**P-026**

# Police Modifier Bulletin

Date: 1 March, 2017

### **2013MY and beyond Utility Police Interceptor Vehicle Modifications and Sealing**

Figure 3

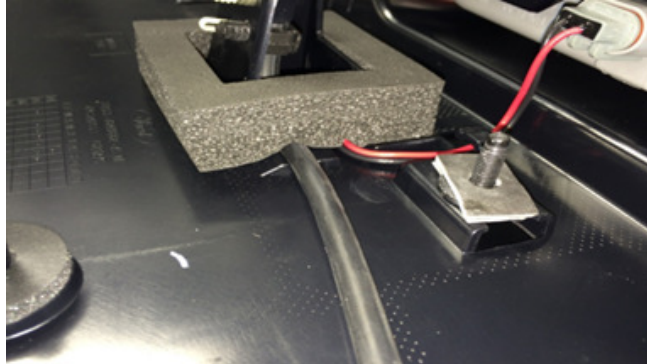
- Removal of the rear spoiler requires thorough sealing upon reinstallation.
- Inspect the foam tower seal and ensure that the wiring and washer line are properly routed and are not comprising the sealing interface (see Figure 3).
- Repair and/or re-seal as necessary using Motorcraft Seam Sealer (TA-2-B).

Figure 4

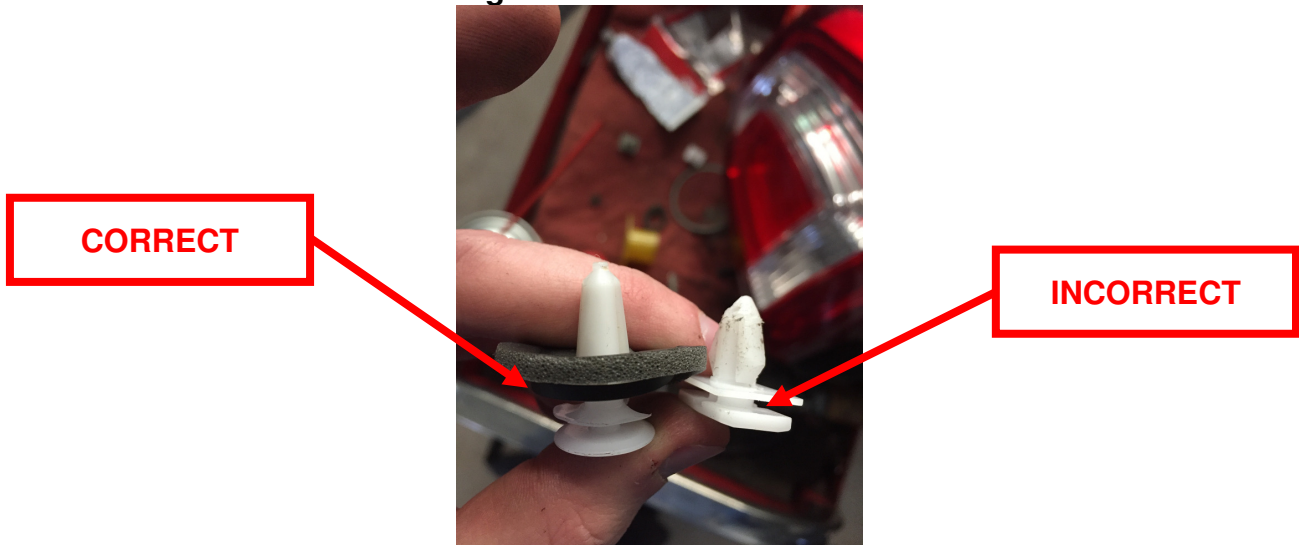
- Replace any damaged plastic retainer clips with close attention to the foam gaskets.
- Repair any deformed sheet metal to ensure a good seal.
